# Proposal for IEEE 1500 Standard

Grammar and architecture support

in IEEE 1149.1 BSDL

CJ Clark Intellitech

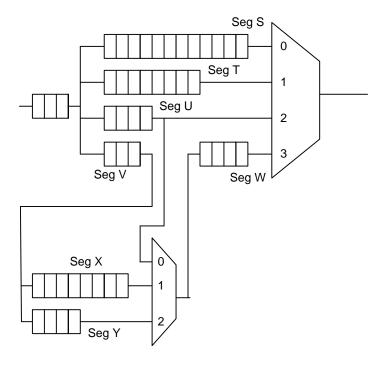
I call the unlabeled 3 bit register as "A". 4:1 mux is M1, and 3:1 mux is M2 Note that in R\_A we have:

We have a <reg or seg name> already, so rather than using SEGMENT, SEG\_S is a register segment (it's not a whole TDR). Then those are used by the mux or instantiated in the R\_A as something in the chain.

So SEGMENTVAL is not pointing to named segments but actual register segments. Like "IS" it is the instantiation of a segment (little s) in a R\_A description. I'm using it directly trying to avoid 'instantiating it' with ... IS ... as to me, if it is instantiated then it EXISTS and is in the scan path. I'm keeping R\_F and instance names as we have already defined as the item in the TDI-TDO path.

The simple 1500 drawing then is as follows (note this is not all of 1500 but the simple drawing of the basic 1500 concept. They are shy on examples in the standard

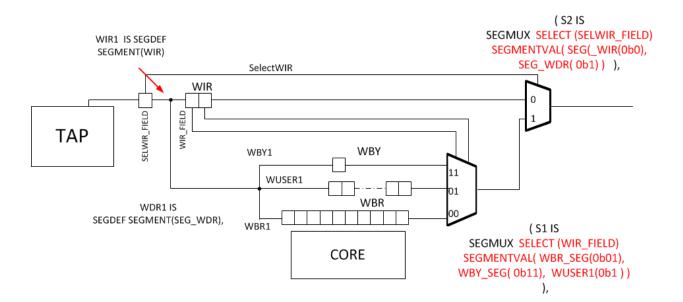
```
Attribute REGISTER_ASSEMBLY of mychip : entity IS
"SEG_WIR ( " &
" ( WIR_FIELD[2] ResetVal(0b00) TAPReset ) "&
"), " &
"SEG_WBY ( " &
" ( WBY[1] ) "&
"), " &
"SEG WBR ( " &
   ( WBR[1] ) "&
"), " &
"SEG_WUSER ( " &
    ( WUSER[20] ) "&
"), " &
"SEG_WDR ( " &
"(D1 IS SEGMUX SELECT(WIR_FIELD) "& -- 3:1 mux
   " SegmentVal( SEG_WBR(0),SEG_WUSER(1), SEG_WBY(3) ) ) "&
")";
Attribute REGISTER_ASSEMBLY of mychip : entity IS
"REG 1500 ( " &
   "(SELWIR_FIELD [1] ResetVal(0b0) TAPReset ), "& -- first bit in chain
   "(D2 IS SEGMUX SELECT(SELWIR FIELD)
                                          " &
   -- SEG_WIR or SEG_WDR
    ")";
```

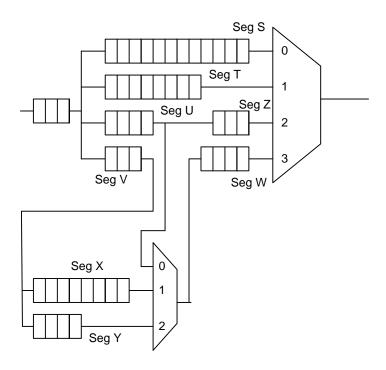
Note that two muxes are in the description and two are in the schematic.

Note that there are two muxes in the schematic and two SEGMUX statements. Note how the SHARED keyword on U would allow a tool to prevent access during mission mode operation. Unfortunately, there is not a mechanism to know what Design Specific Instructions are mission mode and what ones are not.
